SUBJECT: Responds to 871111 request for mod of info re ATWS
 Mitigation Sys Actuation Circuitry plant-specific design
 concerning Generic Ltr 83-28. Implementation package to be
 provided by end of May 1988.

Donald C. Cook Nuclear Plant Units 1 and 2
Docket Nos. 50-315 and 50-316
License Nos. DPR-58 and DPR-74
GENERIC LETTER 83-28 ANTICIPATED TRANSIENT WITHOUT
SCRAM (ATWS) MITIGATION SYSTEMS ACTUATION CIRCUITRY
(AMSAC) ADDITIONAL INFORMATION

The purpose of this letter is to respond to your staff's November 11, 1987 telephone request to modify the information on our AMSAC plant specific design.

AMSAC LOGIC DIAGRAM

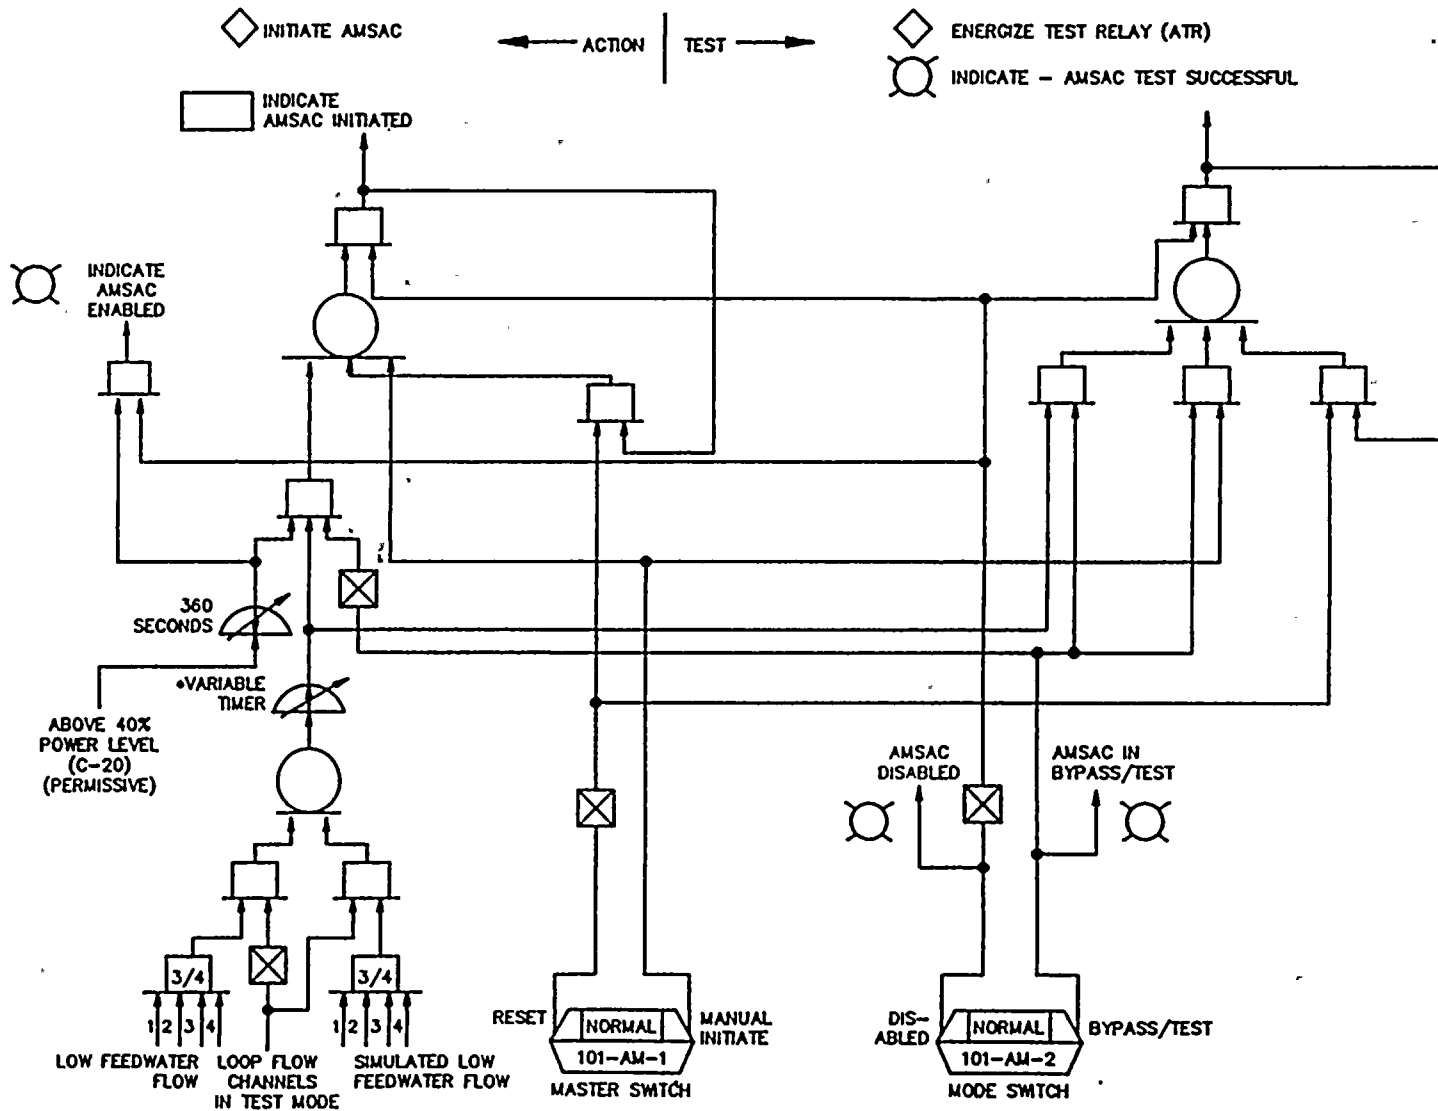
Attachment 2 contains our logic diagram for the AMSAC. Originally we had envisioned using four control switches. As a result of our human factors review, we will be using only two control switches as shown on the diagram. We believe the two switches contain the same capability as the four switch configuration and some consolidation is achieved.

FIGURE 3-8: AMSAC VARIABLE TIME DELAY

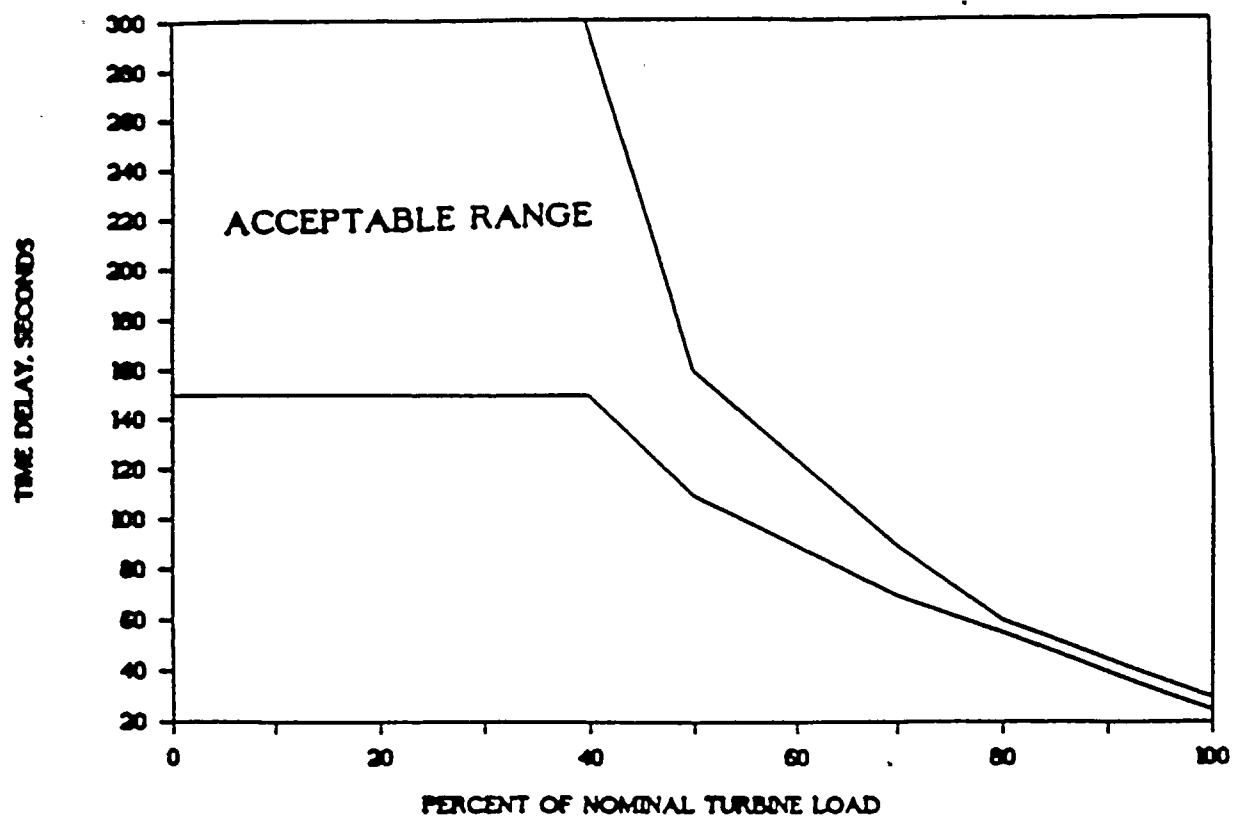
The variable timer performance characteristic will be within the Westinghouse-specified acceptable limits. Attachment 3 is a graph showing initiation timer delay vs. power level, which was published by Westinghouse.

AMSAC CONTROL SWITCHES IN THE CONTROL ROOM DTU PANEL

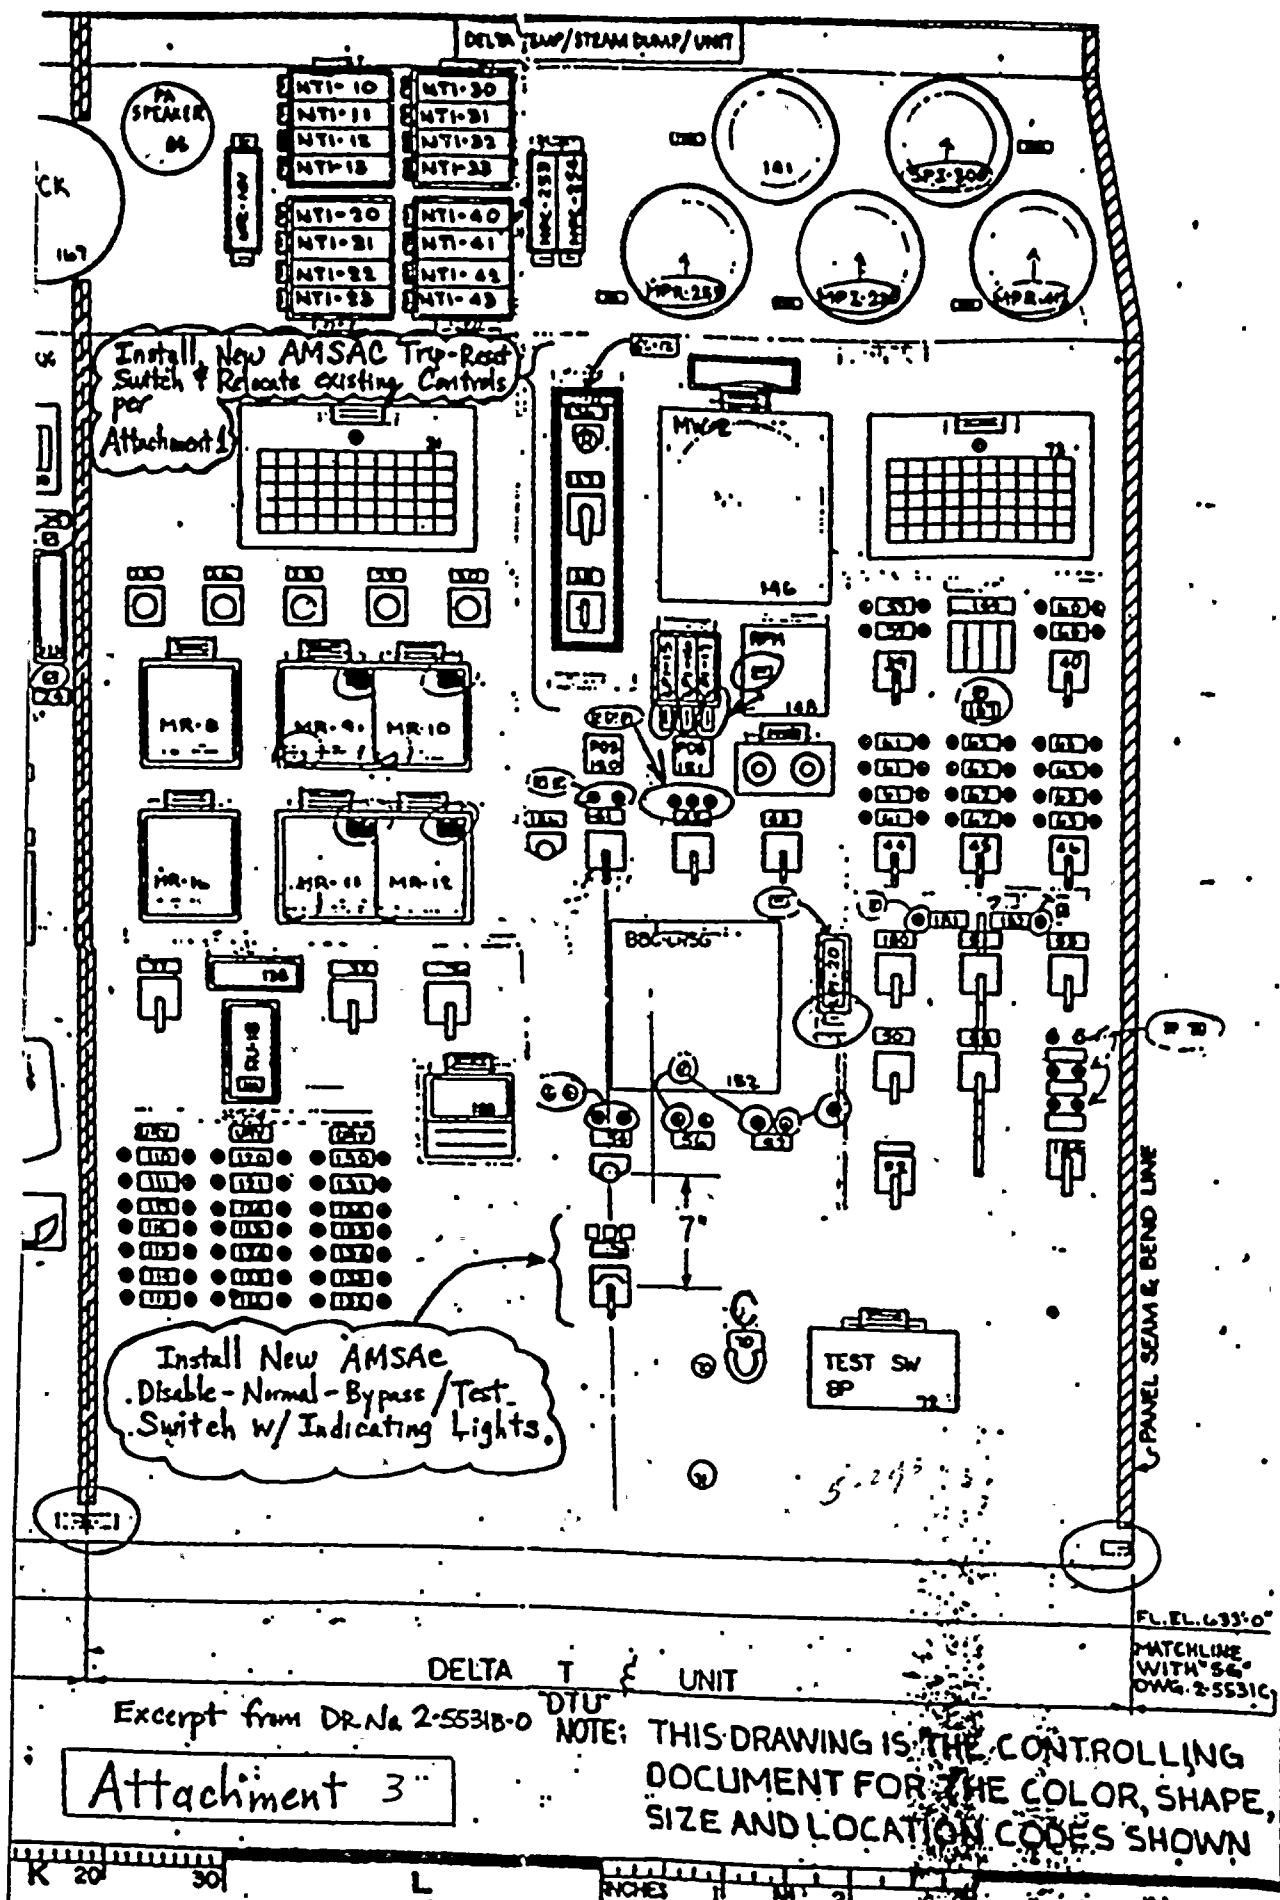
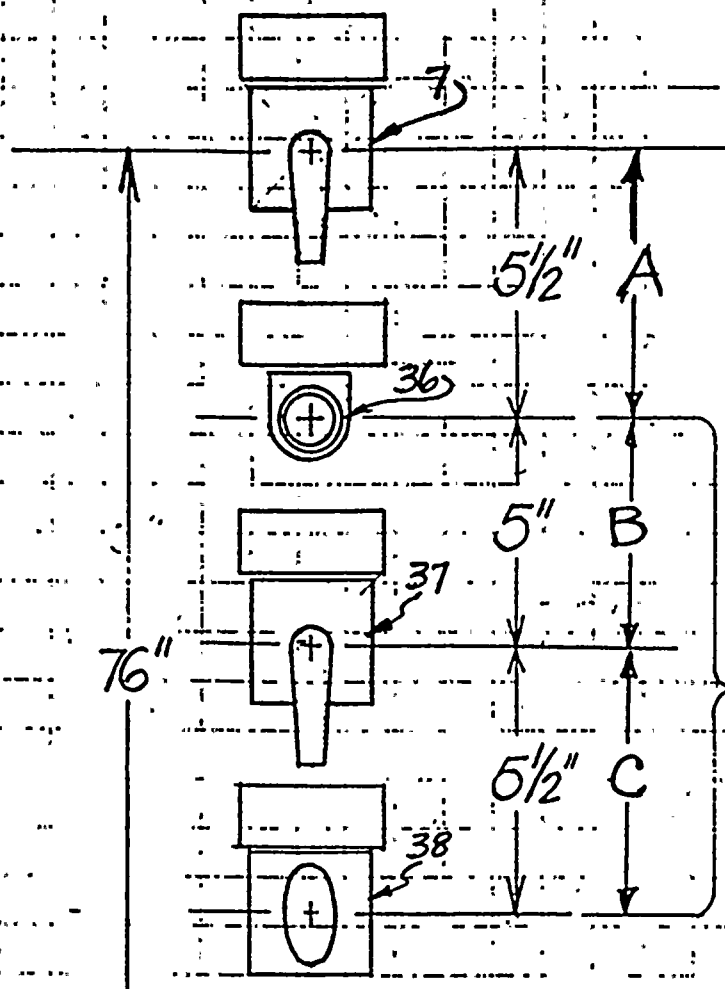
AMSAC will be disabled for repair and maintenance. This will be accomplished through a bypass switch whose status will be continuously displayed in the control room. We have completed a human factors review and Attachment 5 contains the figure showing the future switch locations and configurations which are consistent with the results of the review. The switch will be used by plant operators, and plant procedures will be written to incorporate proper operating and maintenance sequences.

Manual initiation of AMSAC at the system level will be accomplished through a control switch. Please see Attachment 5 for the switch configurations and locations which resulted from our Human Factors Review.
